Important Notices

TOSHIBA Microcontrollers TLCS-870 Family
TLCS-870/C1 Series

Restrictions on the Voltage Detection Circuit

Datasheet Corrections: Electrical Characteristics of the Power-On Reset Circuit

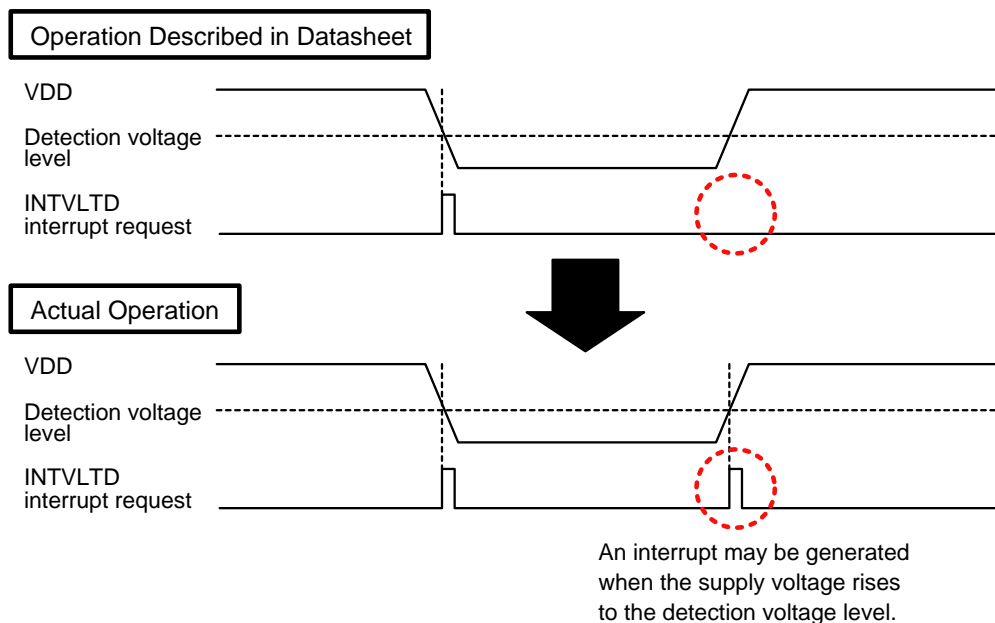
This is to inform you of restrictions on the voltage detection circuit in the TLCS-870/C1 Series of microcontrollers.

1. INTVLTD Interrupt Request

When interrupt generation is enabled in the voltage detection circuit, an INTVLTD interrupt request may be generated not only when the supply voltage falls to the detection voltage level, but also when it rises to the detection voltage level.

In ICE mode of the In-Circuit Emulator (TMP89C900), no interrupt request is generated when the supply voltage rises to the detection voltage level. Therefore, with products supporting the In-Circuit Emulator (TMP89C900), the interrupt generation operation may differ between the development tool and the actual product.

2. Releasing STOP Mode by Voltage Detection

The SRSS bit in the voltage detection control register 2 (VDCR2) provided for releasing STOP mode by voltage detection cannot be used because it does not function as expected.

1. INTVLTD Interrupt Request

Do not use the INTVLTD interrupt for voltage detection. The voltage level should be regularly checked using other timing such as the execution cycle of the main program. VDCR1<VDxSF> (x=1, 2) can be used to check the voltage level. However, if the operating voltage is near the detection voltage, the VDCR1<VDxSF> value may become unstable. It is recommended that VDCR1<VDxSF> be tested multiple times to determine the voltage level.

2. Releasing STOP Mode by Voltage Detection

Always set VDCR2<SRSS> to "00". Use the STOP pin to release STOP mode.
